## INA Service Info

# Tensioner pulleys 531 0535 20 and 531 0819 10

## Risk of mix-ups

Part no.: 531 0535 20  
 531 0819 10

Fig. 1: 531 0535 20 – Old design (left), new design (right)

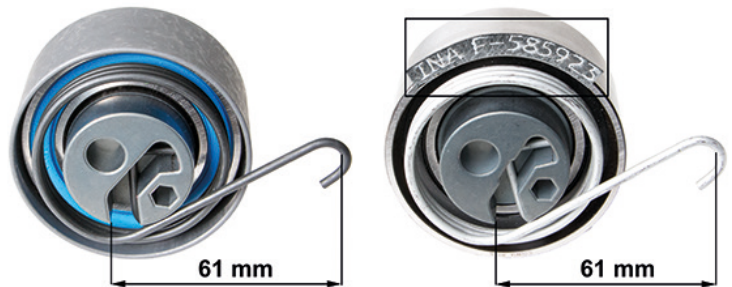
Tensioner pulleys 531 0535 20 and 531 0819 10 are replaced by a new design, whereby the part numbers have not changed. The modifications make it easier to distinguish the two types from one another.

The clearest distinguishing characteristic is the product number printed on the part and the colour of the spring steel (Fig. 1 and Fig. 2).

The new designs also feature track rollers with a ground surface and the spring steel used is corrosion resistant.
